SUBJECT: PLANS AND PROPOSAL ADDENDUMS

PROJECT: BR 2B23(020)

CONTROL: 0314-05-046

**IH-20  
EB ML IH 20 OVER SOUTH FORK  
PALO PINTO CREEK BRIDGE  
BRIDGE LAYOUT**

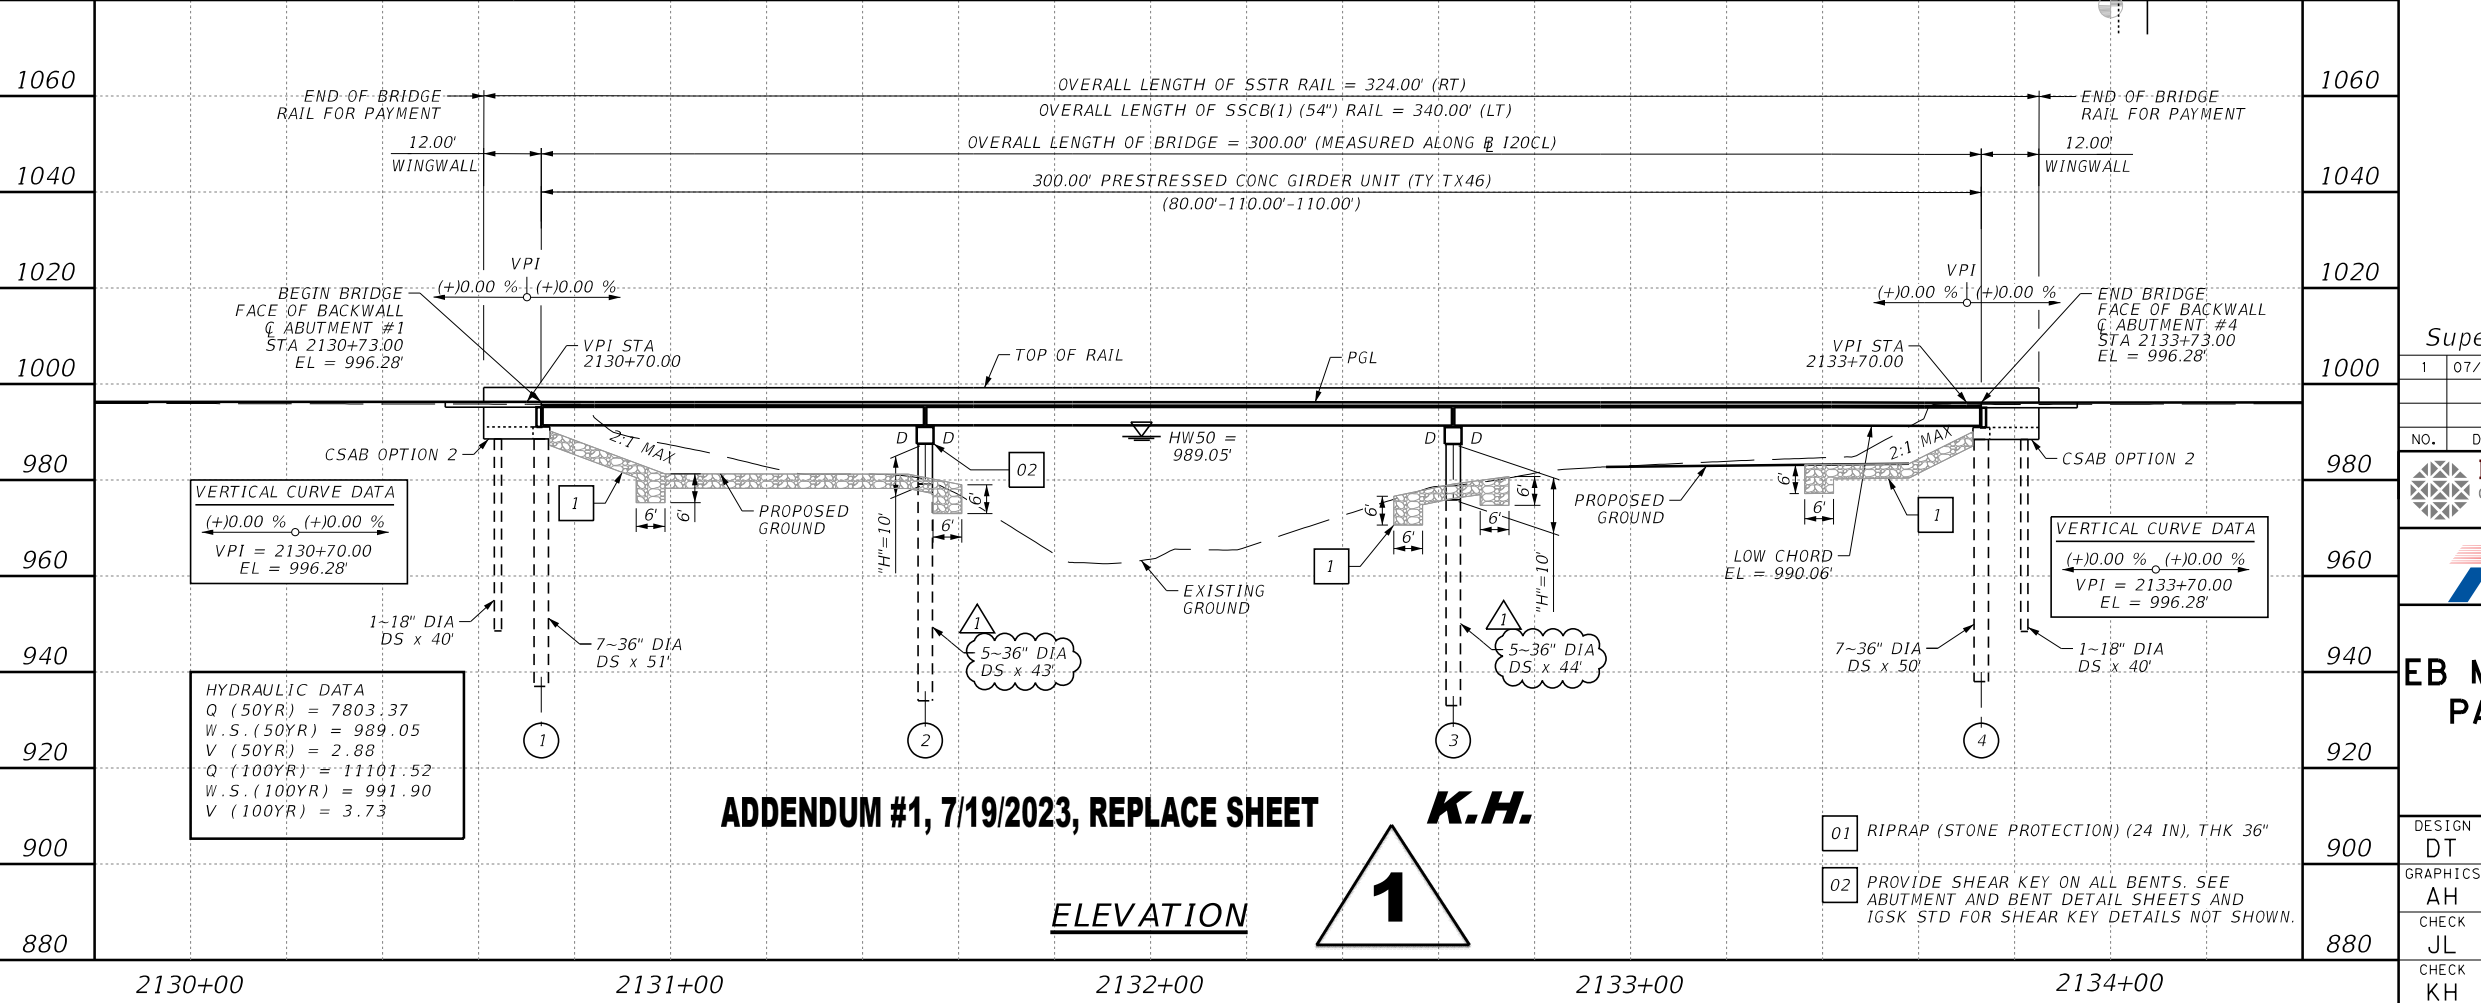
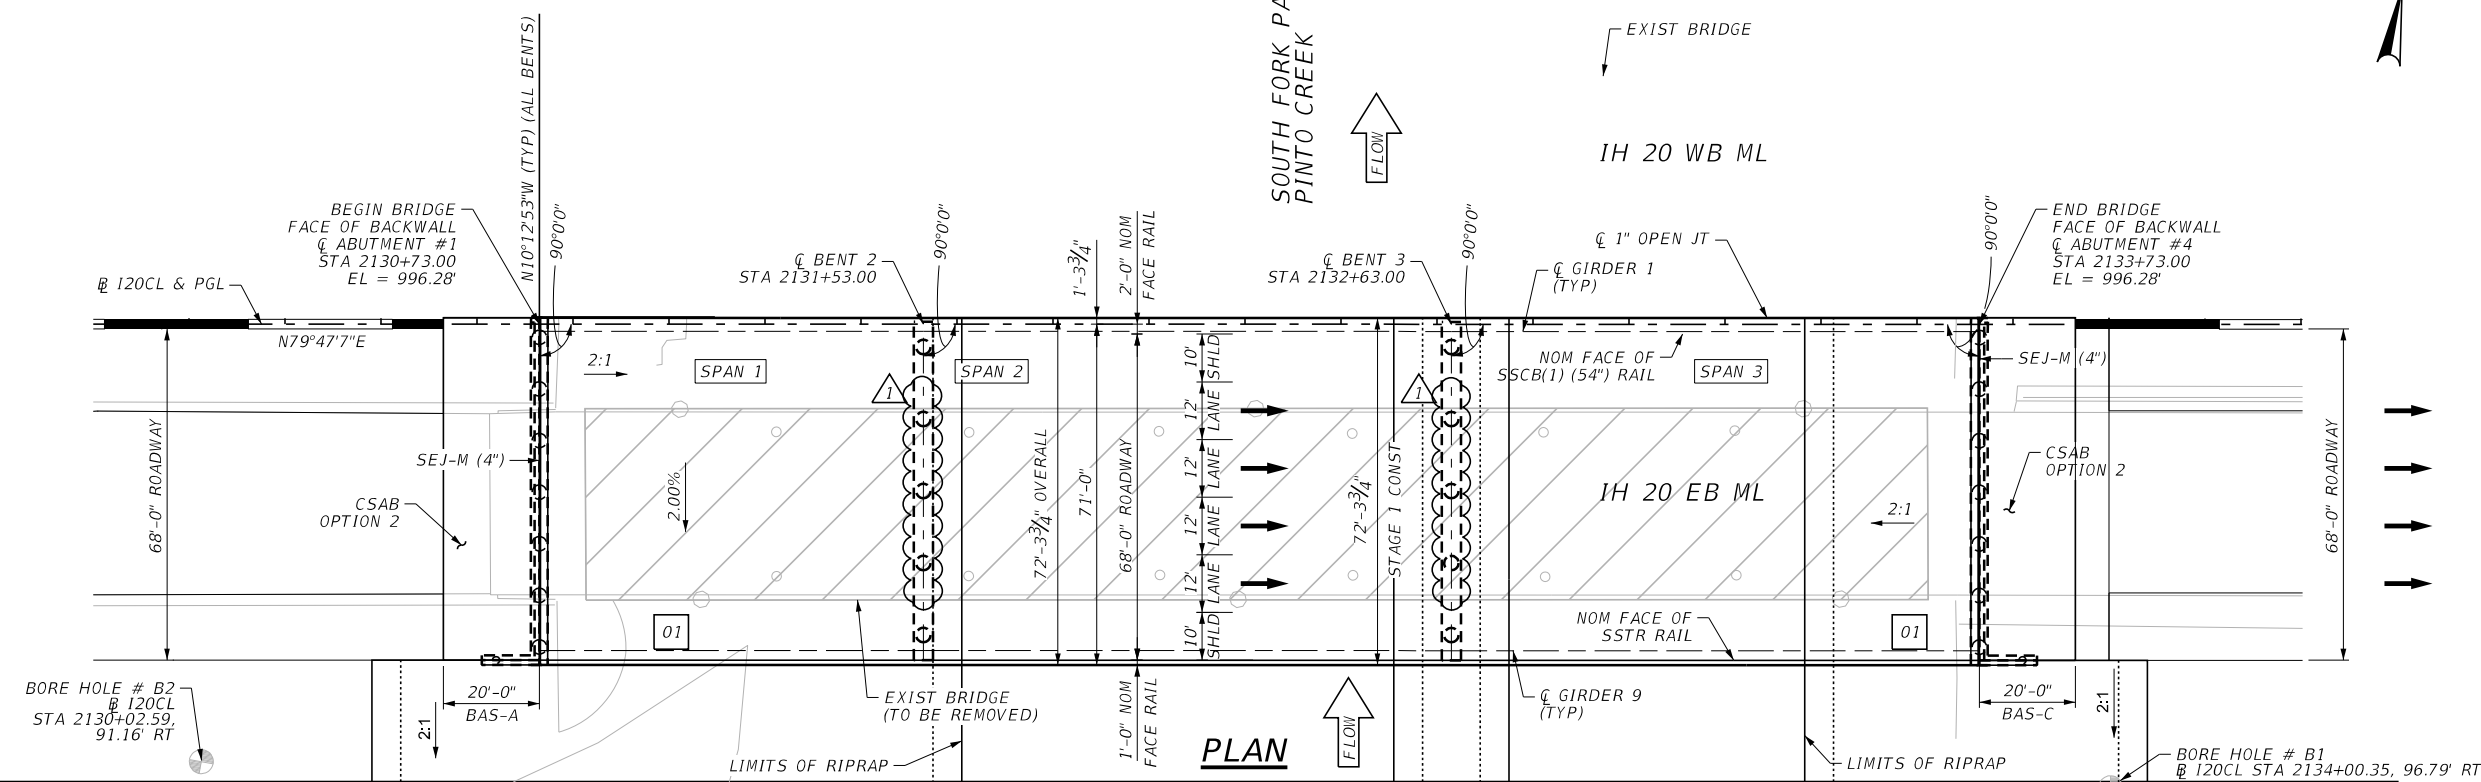
NO.	DATE	DESCRIPTION	APPROV.
1	07/18/23	ADDENDUM 01 ADDED 1 COLUMN AT INT BENTS	KH

**IH-20  
 WB ML IH 20 OVER SOUTH FORK  
 PALO PINTO CREEK BRIDGE  
 BRIDGE LAYOUT**

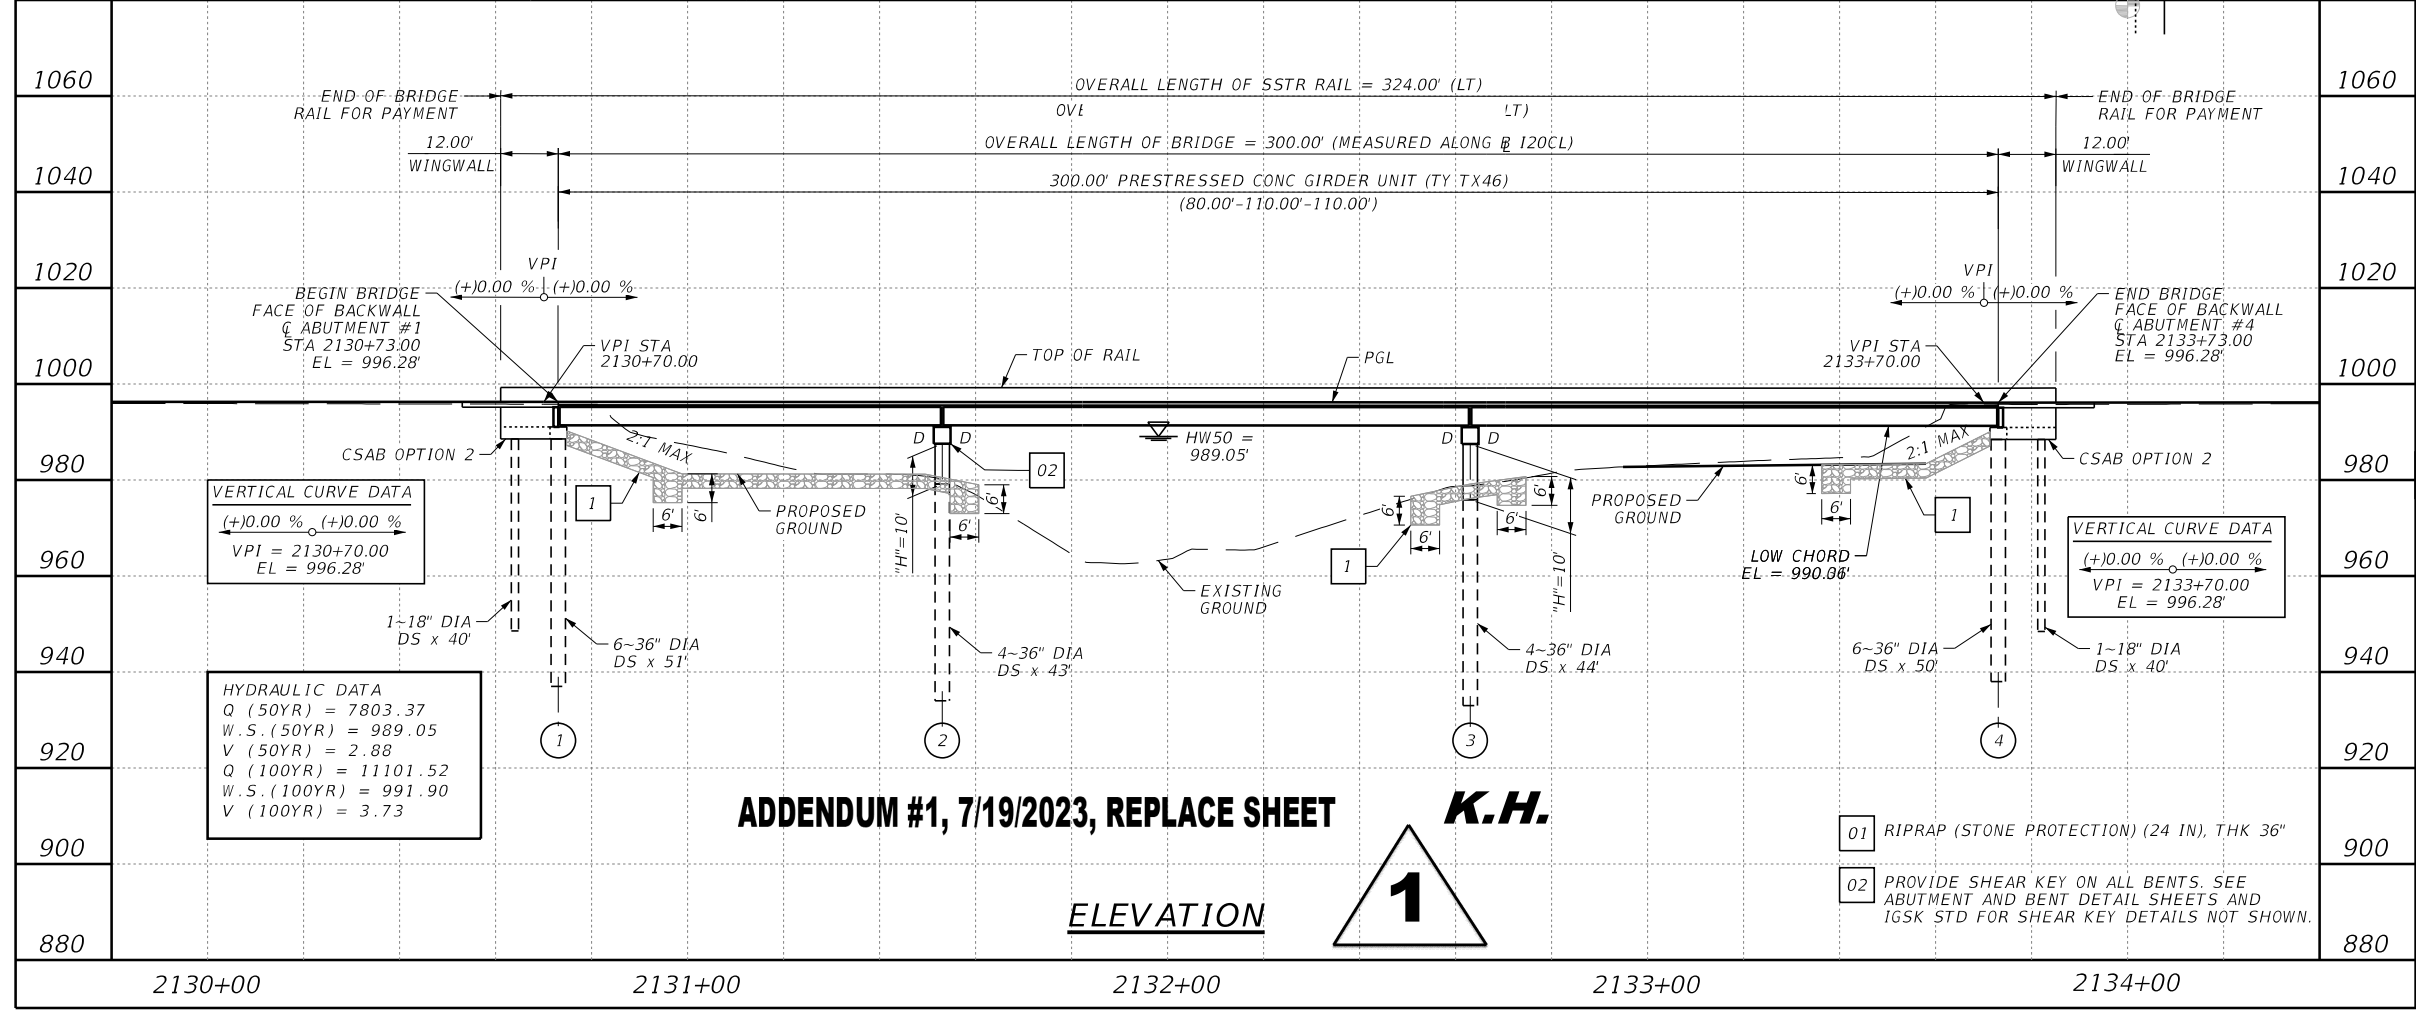
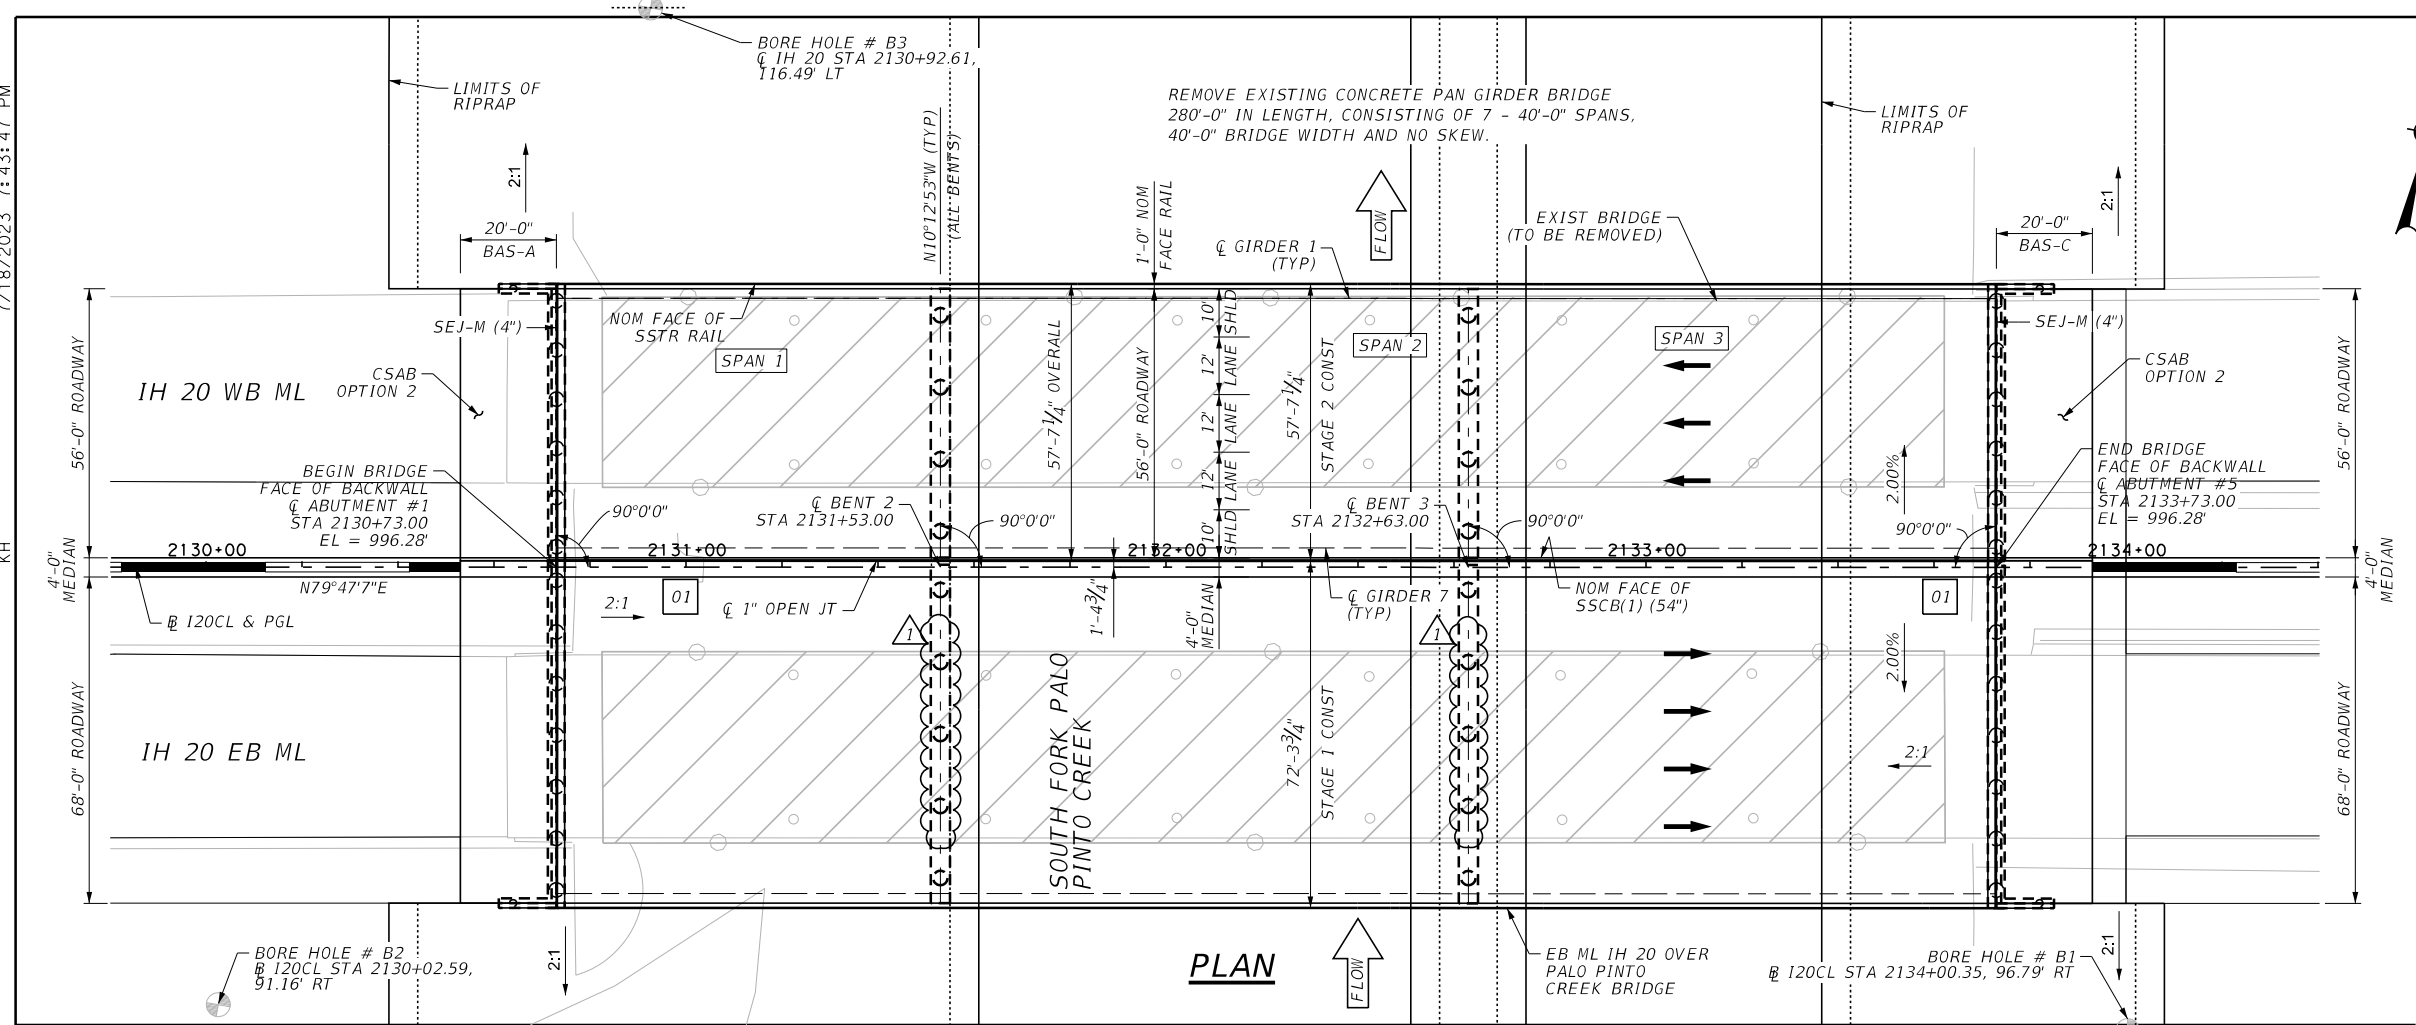
NO.	DATE	DESCRIPTION	APPROV.
1	07/18/23	ADDENDUM 01 ADDED 1 COLUMN AT INT BENTS	KH

**IH-20  
SOUTH FORK PALO PINTO  
BRIDGE  
TYPICAL SECTION**

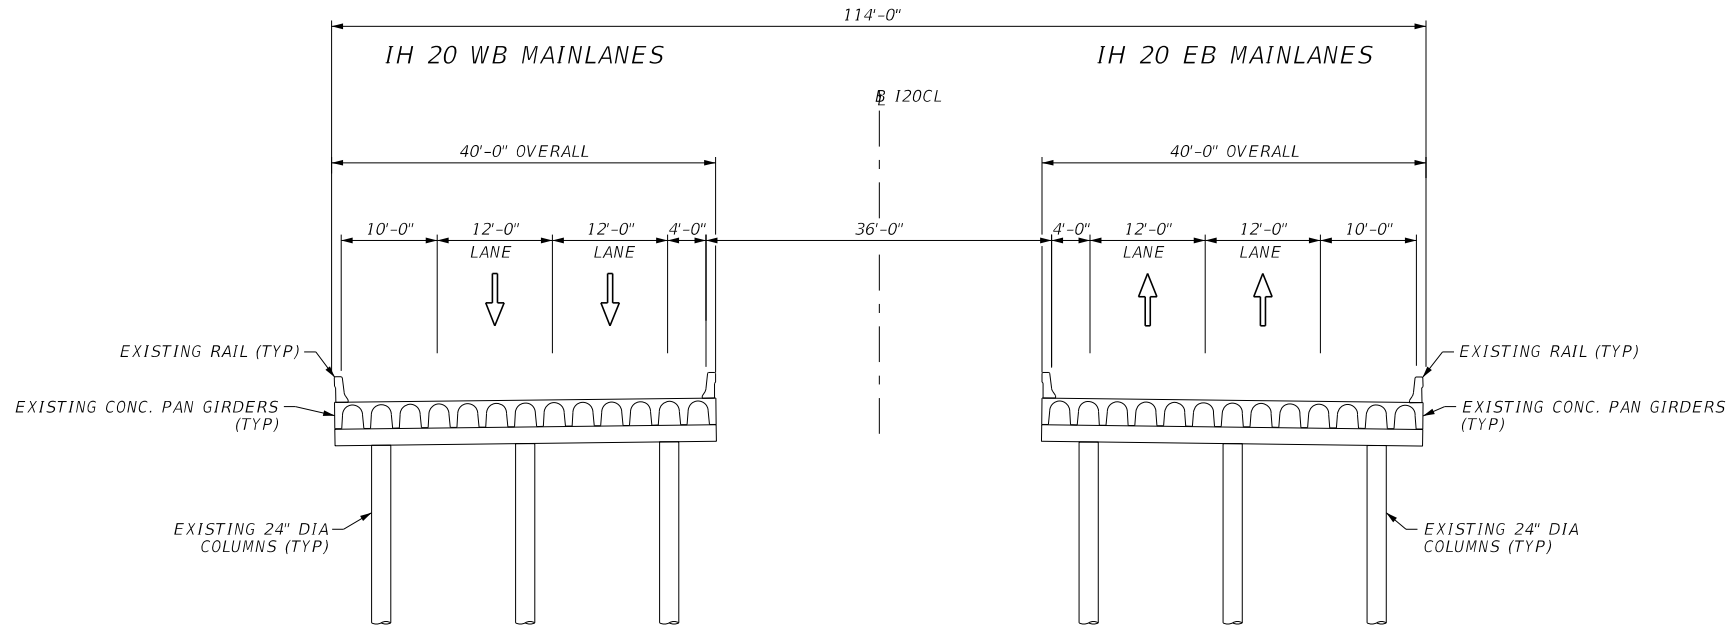
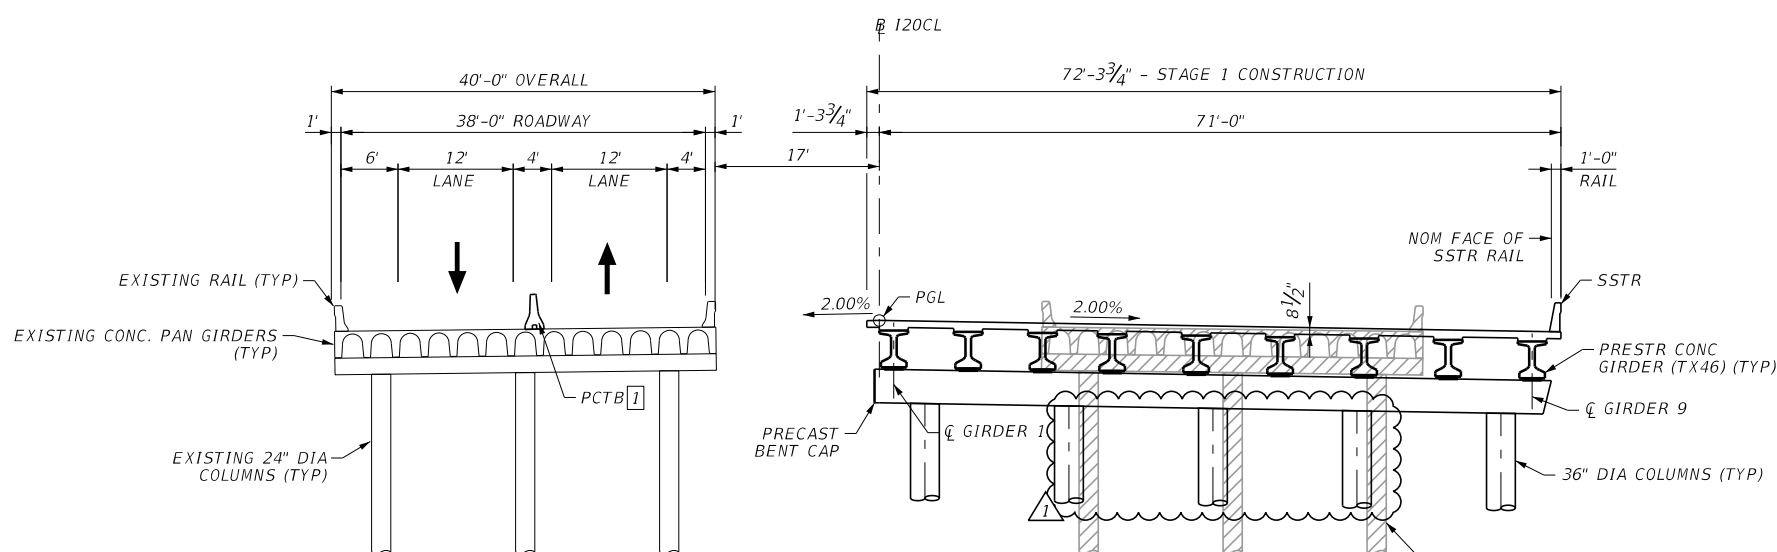
1	07/18/23	ADDENDUM 01	ADDED 1 COLUMN AT INT BENTS	KH
NO.	DATE	DESCRIPTION		APPROV.
